To: **Norwich City Council / Norfolk County Council**
From: **Iceni Projects (Transportation)**
Date: **January 2023**
Title: **Anglia Square, Norwich – Revision C Note**

Table 1 Updated Highway Proposals

Schedule of changes to drawings - Rev A to Rev C

SITE LAYOUT REVIEW
(SKODA)

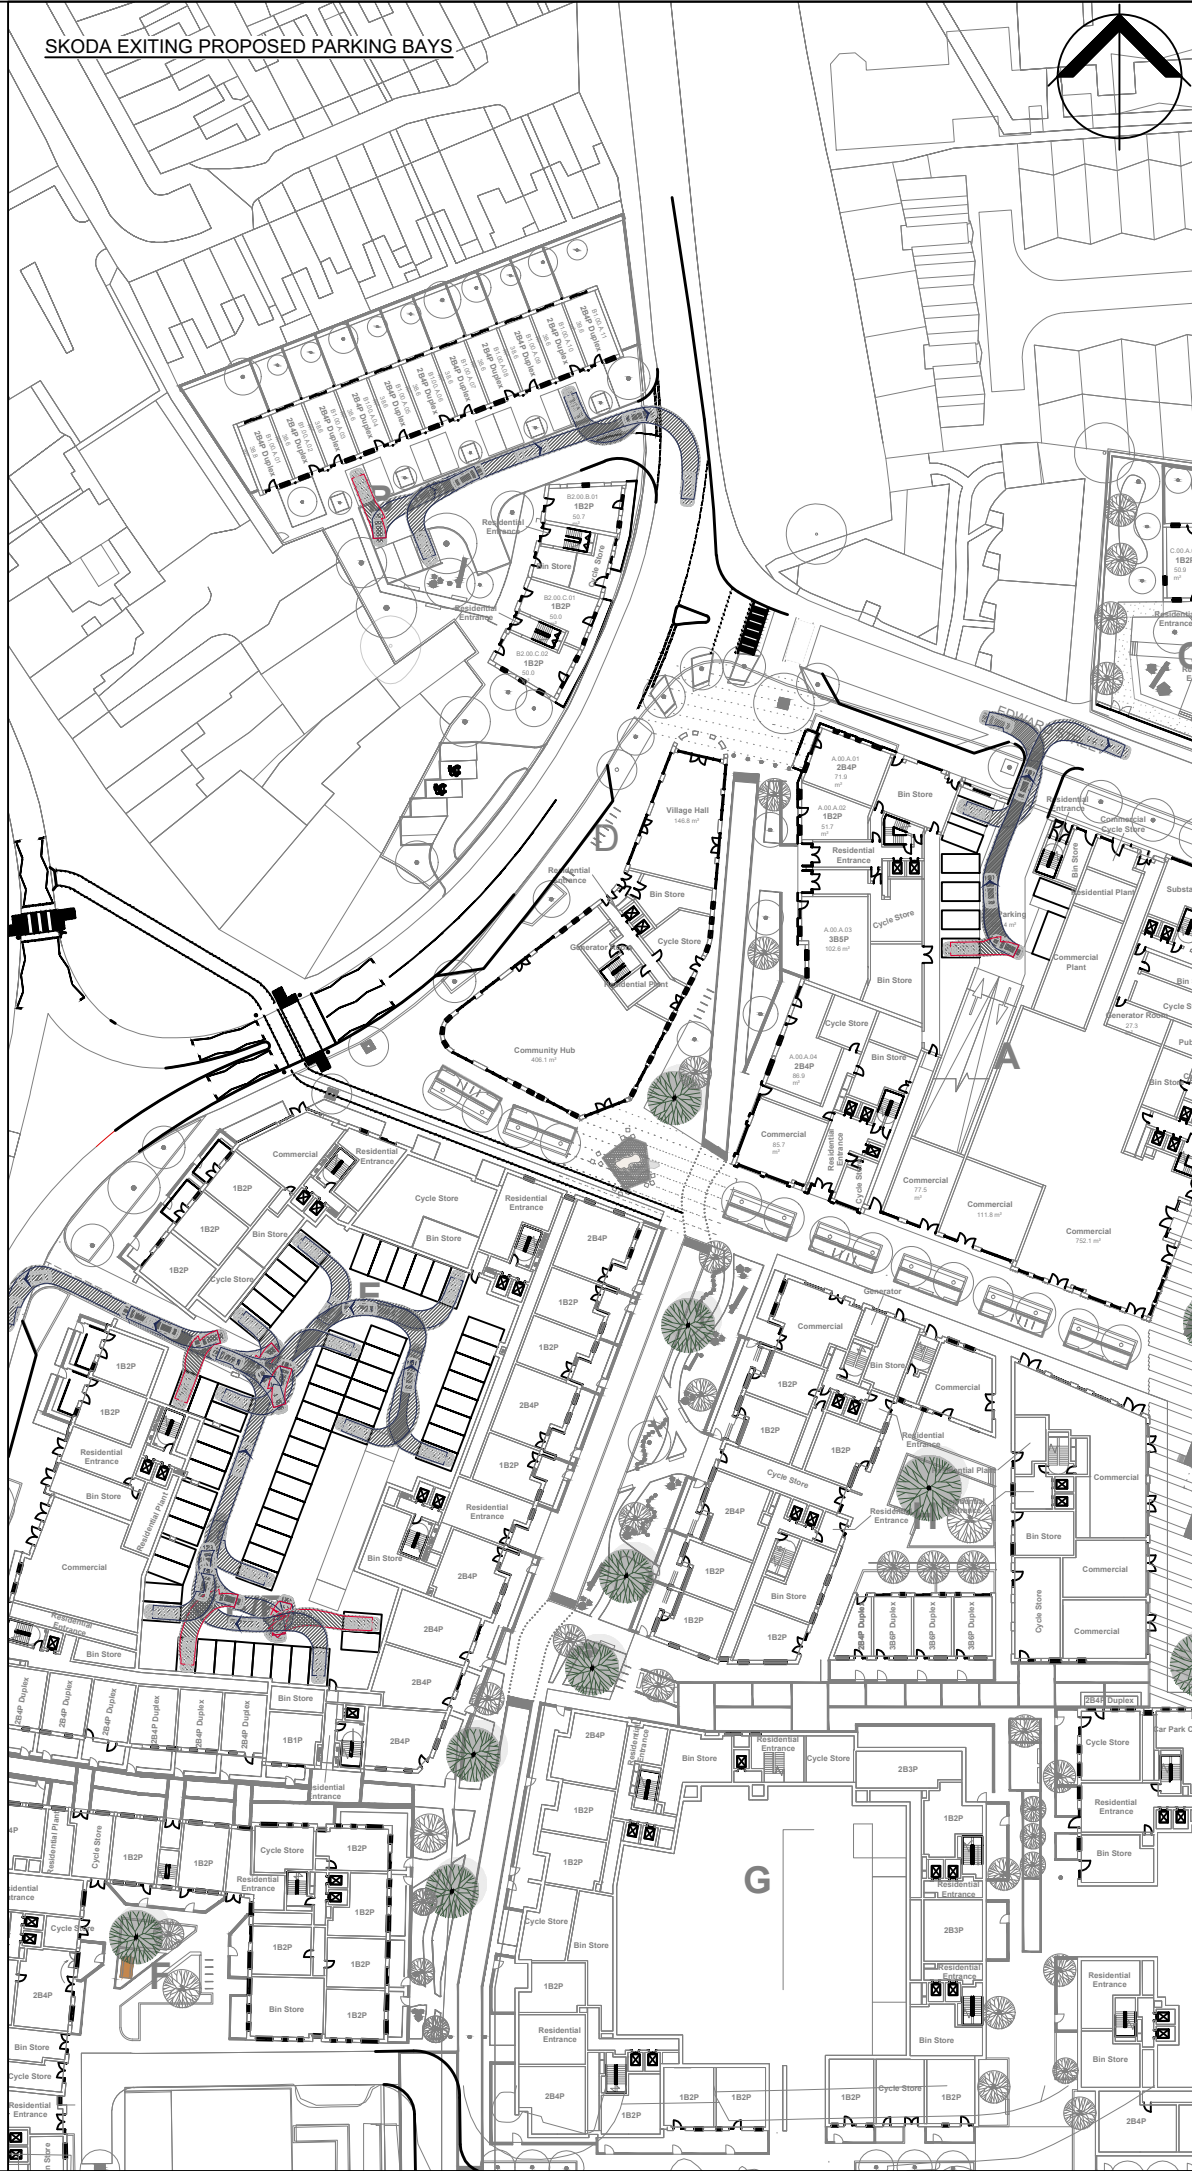
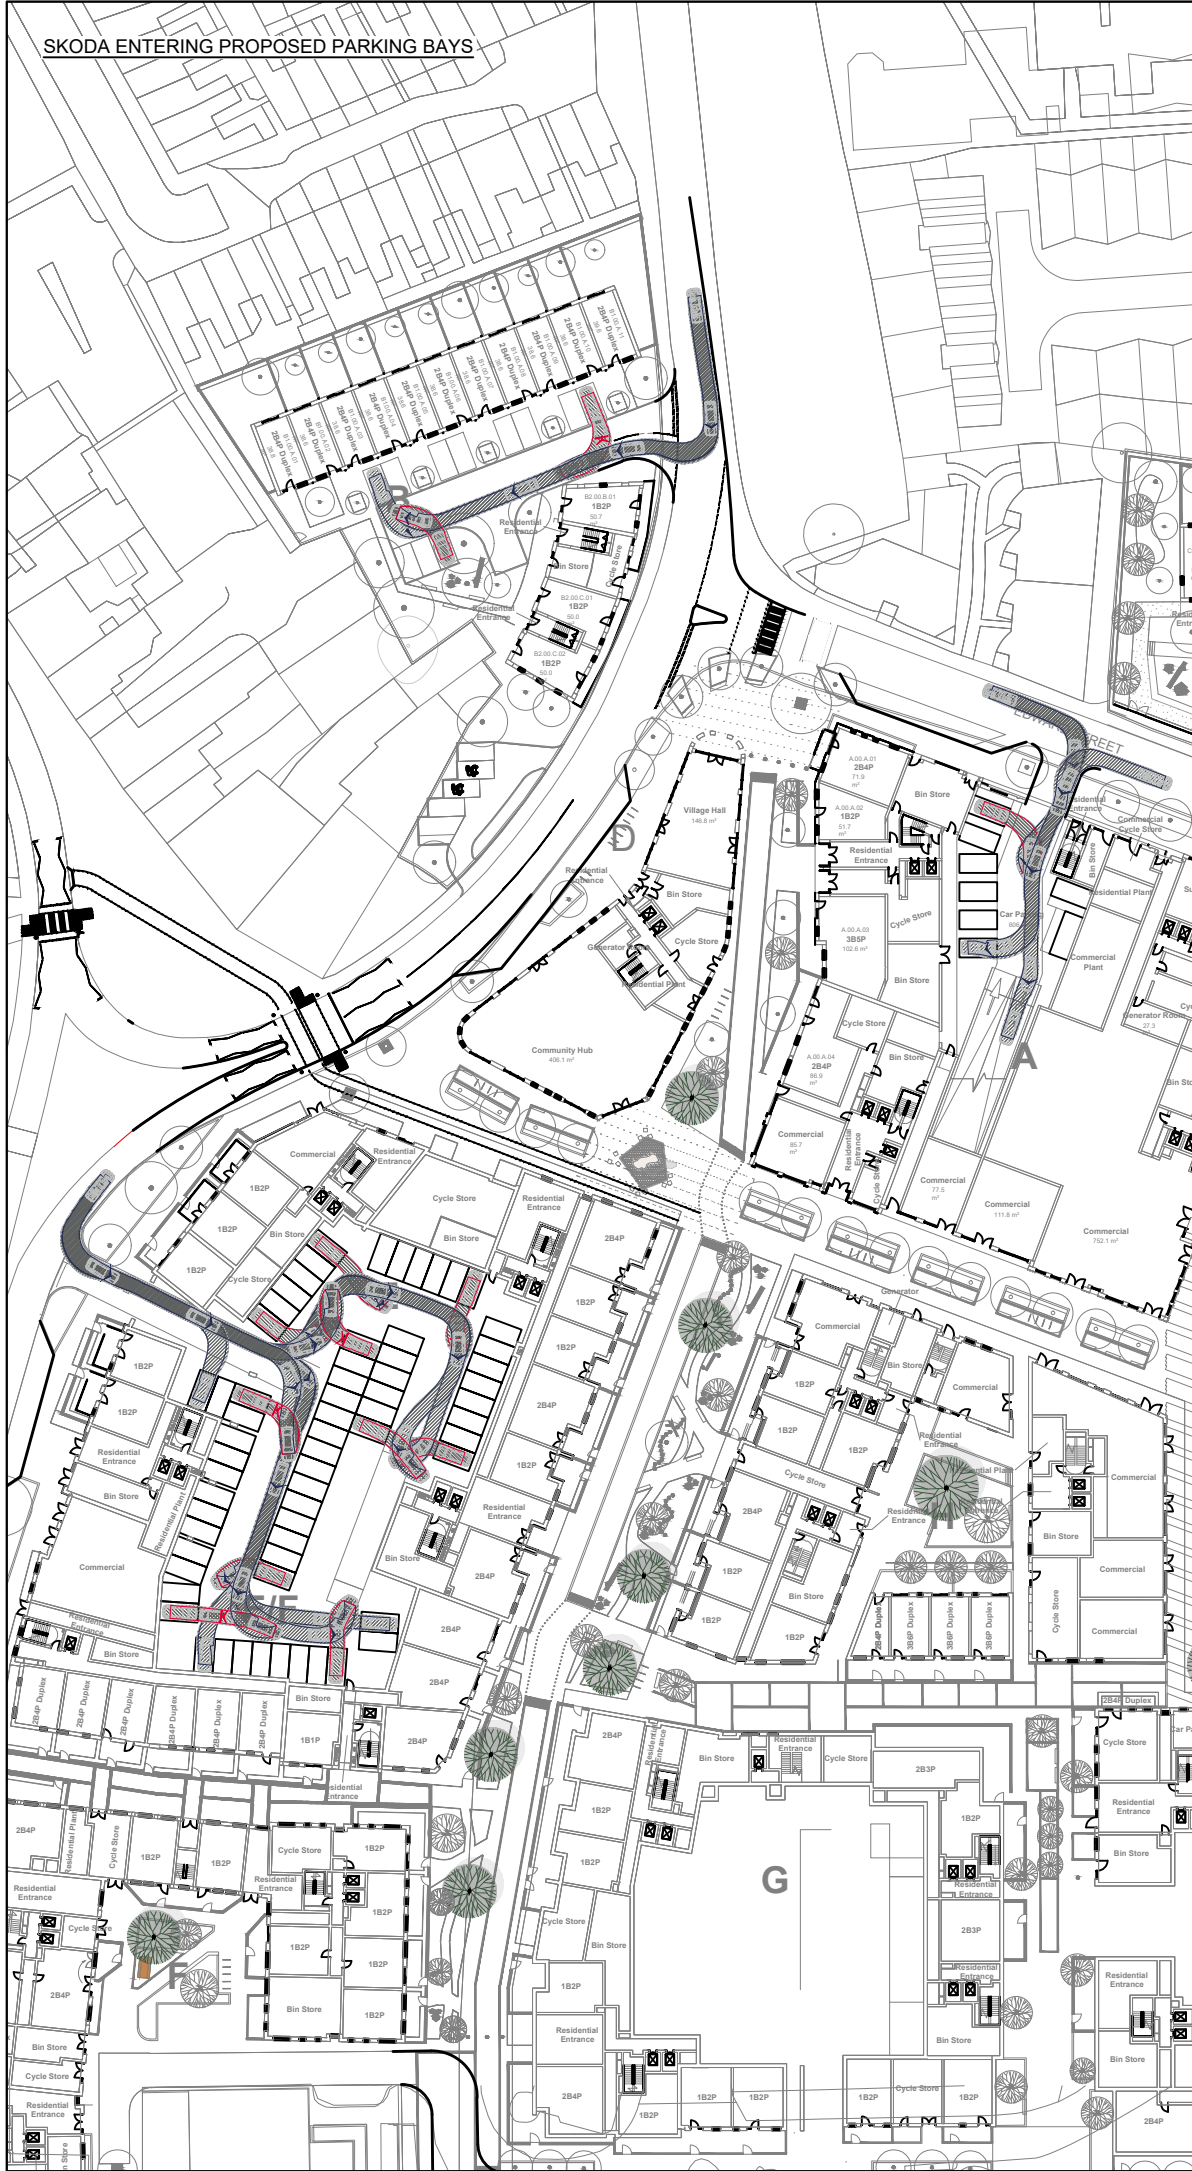
| Rev.A Drawing No. | Rev.C Drawing No. | Difference Between Proposals | Comments |
|---|--|---|---|
| <p>None</p> <p>21-T123_41.1A</p> <p>21-T123_41.2A</p> | <p>21-T123_32G</p> <p>21-T123_45A</p> <p>21-T123_46A</p> | <p>In order to ensure that the development proposals allow for all vehicle movements. Further iterations to the previous tracking proposals have been produced. These drawings show car, refuse vehicle, and fire tender vehicle movements throughout the site.</p> <p>The tracking drawings show that the area provided for vehicle movements is sufficient and does not impact on the surrounding landscaping/building edge detailing.</p> | These changes are all minor amendments and are not considered as a material change to the planning application. |
